**Economic and Social Council**

World Forum for Harmonization of Vehicle Regulations**Working Party on General Safety Provisions****118th session**

Proposal for a new UN Regulation on uniform provisions concerning the approval of motor vehicles with regard to the Moving Off Information System for the Detection of Pedestrians and Cyclists**Submitted by the Informal Working Group on Awareness of Vulnerable Road Users proximity in low speed manoeuvres**

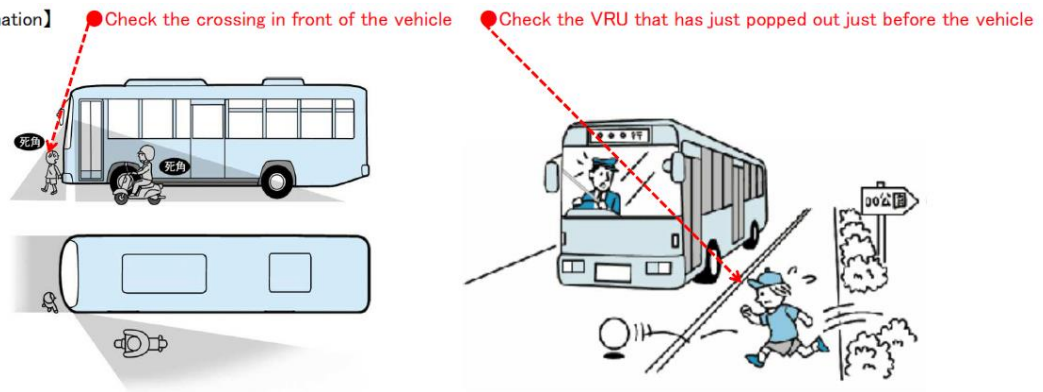
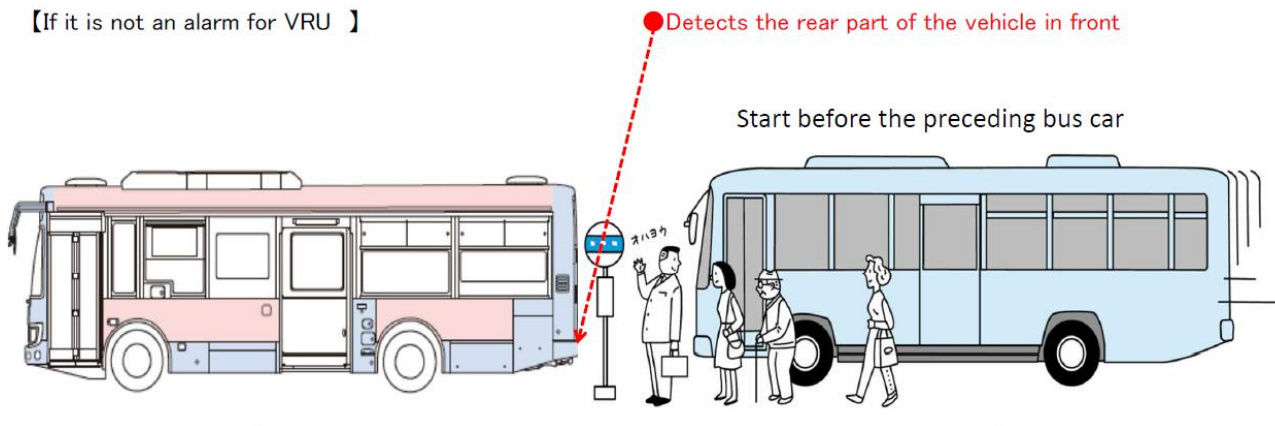
OICA-CLEPA

We would like to avoid the automatic reactivate; request for keeping it switched off even after the master control switch activation.

【Proposal】 :It is necessary to set the SW to always turn off.

- As a route bus service in Japan, we frequently repeat starting, stopping, starting, and stopping. When the vehicle is stopped, consider the environment and stop the engine.
- At the time of starting, the driver checks the safety directly from the field of view and starts.
- According to the provisions of 5.4.4 of the original plan, the detection function is turned on every time the vehicle starts, and the VRU in front of the vehicle is detected and an alarm is issued.
- After confirming the warning as the driver's action, and after confirming the safety directly from the visual field, the vehicle will start, so that the driver feels annoyed and hinders safe driving.

- At the bus stop of a Japanese route bus, there is no gap behind the preceding bus and the following bus stops. Stop the engine considering the environment.
- When the following bus starts ahead due to the difference in the number of passengers getting on and off, the driver of the following vehicle will detect the preceding vehicle as VRU and the warning will be issued.
- The driver recognizes this as a false alarm.
- The driver feels annoyed and hinders safe driving.

VRU-Proxi#14: master control switch is the vehicle complete switch off.

Technical solution: The engine may be switched off but not the vehicle.
